Access Compliance Report

Public Rights-of-Way

(Curb Ramps)

Intersection ID: 53713	Main Street: N_TRYON_ST	Cross Street: PERIWINKLE_HILL_AV	Location: W
ADA ID: F3CA2EA75E71	Ramp Type: BlendTrans2	Initial Pass/Fail: Pass	Overall Compliance: No
Severity Score: 5			
Codes/Mitigation Info/Possible Solution		Field Measurements/Component Compliance

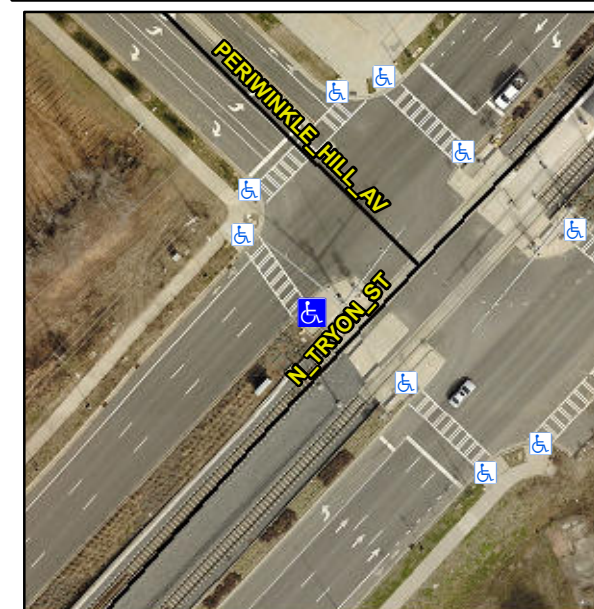
Remove & Replace Curbed Edge.

R304.2.3

Compliance	Description	Data	Compliance	Description	Data
N/A	Ramp Length (in)	157.0	Yes	BlendTrans Slope (%)	2.4
Yes	Ramp Width (in)	121.0	Yes	BlendTrans XSlope (%)	0.1
No	Flare Type	Curbed_WithWalkSurface	Yes	Flare Type	Curbed_NoWalkSurface
N/A	Flare Slope LT (%)	N/A	N/A	Flare Slope RT (%)	N/A
N/A	Flare Traversable LT?	No	N/A	Flare Traversable RT?	No
N/A	Landing Length (in)	N/A	Yes	DWS Provided?	Yes
N/A	Landing Width (in)	N/A	Yes	DWS Contrast?	Yes
N/A	Landing Slope (%)	N/A	Yes	DWS Length (in)	24.0
N/A	Landing X Slope (%)	N/A	Yes	DWS Full Width?	Yes
N/A	Landing Curb? (Y/N)	Yes	Yes	DWS Offset (in)	0.0
N/A	Shared Landing?	No			
Yes	Gutter Ponding?	No	Yes	Gutter Slope (%)	4.1
Yes	Gutter Lip Ht (in)	0.0	Yes	Gutter X Slope (%)	0.2
N/A	Painted X Walk1?	Yes	N/A	Painted X Walk2?	N/A
	X Walk 1 Direction	To NW		X Walk 2 Direction	N/A
	X Walk 1 Width (in)	116.0		X Walk 2 Width (in)	N/A
	X Walk 1 Slope (%)	1.7		X Walk 2 Slope (%)	N/A
